**To:** City Council  
**From:** Planning and Zoning Commission  
**Date:** December 9, 2019  
**Re:** Case #19011 - Edgewater at Creekmoor 7th Final Plat Lots 219 thru 229 and Tracts I & J

Outline of Requested Action: The applicant seeks to obtain Final Plat approval for Edgewater at Creekmoor Seventh Plat – Lots 219 thru 229 and Tracts I & J

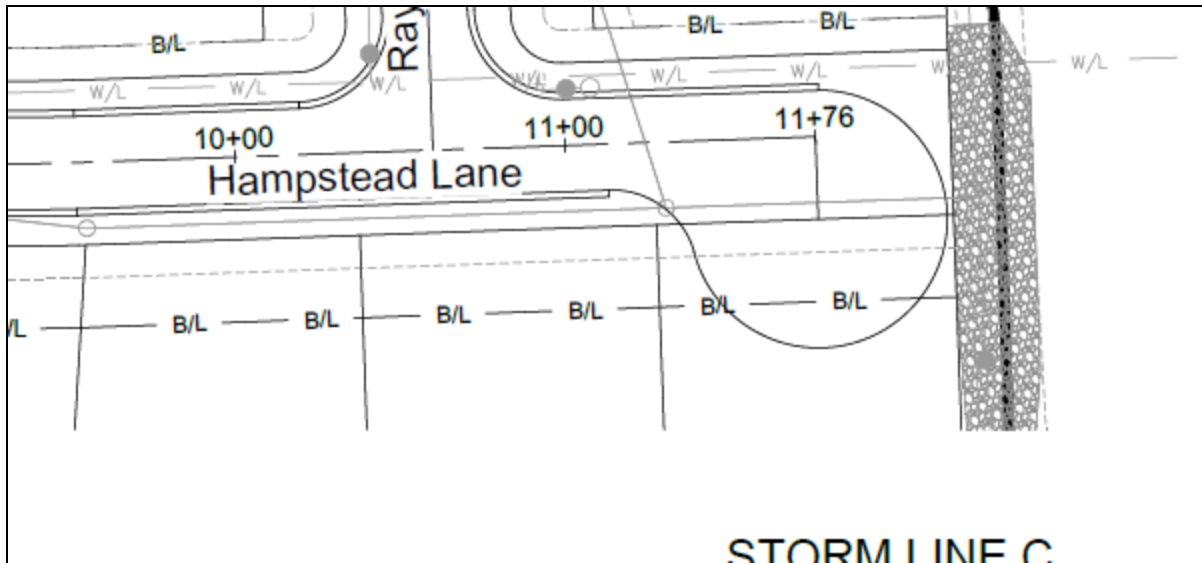
4. The plat and engineering construction drawings have incorporated the new tear-drop design for cul-de-sacs. This design allows for an island to be installed in the cul-de-sac as a water quality measure.
